Government of Madras

Public Works

G.O. No.	721	(w)	Press
B.P. No.			Mis.
Dated	15.3		1875

Suggesting certain
alterations to the
Police Guard room,
now being constructed
at Jeppanur.

Rough ground plan
of Police Guard room
in D. J. Jeyaraj's Canteen.

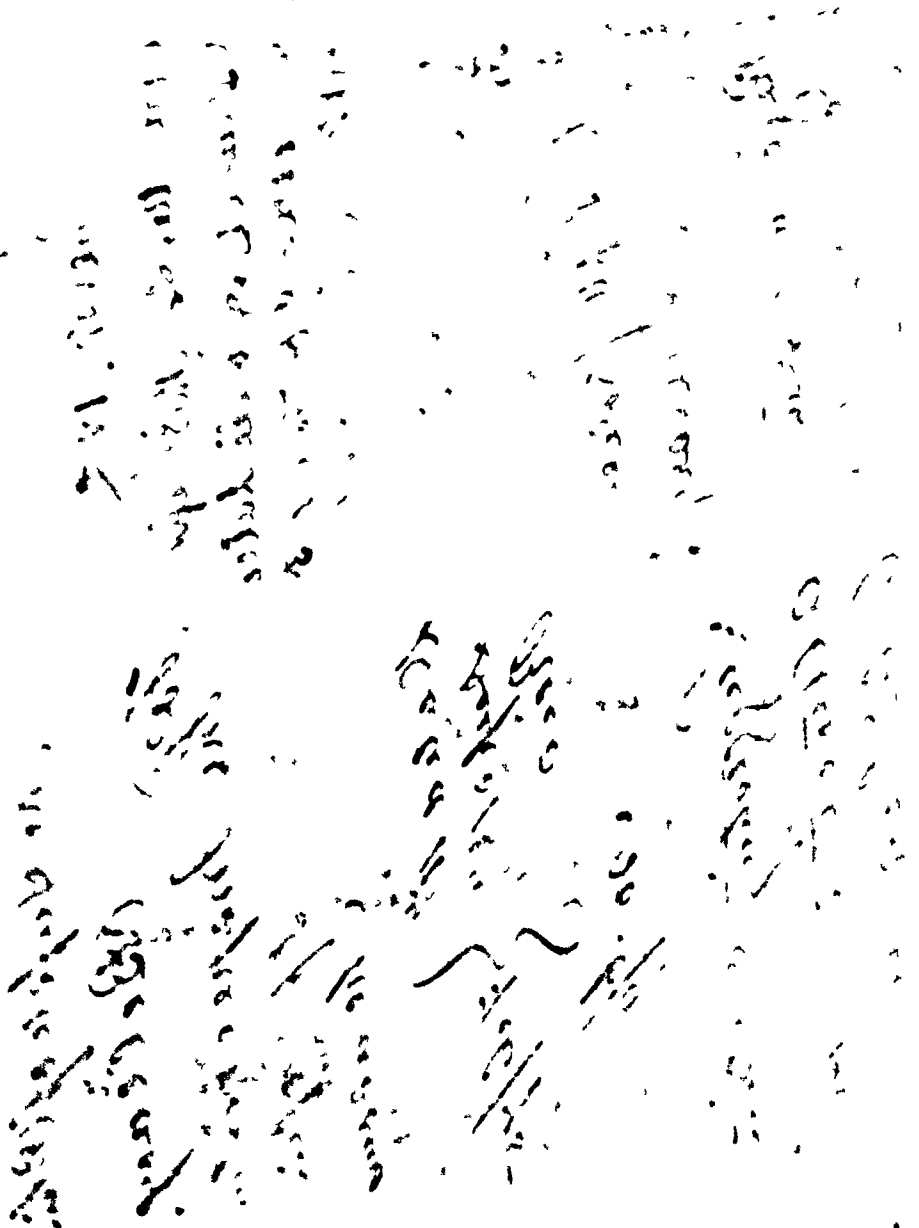
It will of course be necessary for
the Police to have a view of the wards which
run beyond - The guard room on each side,
and it would ~~be~~ consequently inadvisable
for a wall to be carried right up to the
wards; but in my opinion from A to B on
both sides, an ~~small~~ should be substituted
for the open work at present intended and
I even question whether on each side the
wall should not be carried a little further
towards the ward than the points A & B
which are half way from the record room
wall to the wards (but this the R. W. should
decide) - They should stop at such
a point as to allow a free view of the
wards.

These Police
guard rooms
as at present
designed are
regarded from
troops and
within better
than open
wards.

the wall should
be run up
nearly to the
wards, with
a window on
each side at
the points A & B
the whole place
is fairly
if present in
the center
ward will be
broken up -
they and the
power the center
and serge the arms -
there should be an iron
protecting (the) which the Police
and all return the center
ward & guard room and the
doors of the latter should be at
the points A & B -

THE alteration in question, which is
simply the substitution of walls with
windows for open wooden gratings in
the sides of the Police guard-rooms attached to Deputy Tahsildars' Cutcheries,
may be universally adopted, as recommended by the Inspector-General of Police.
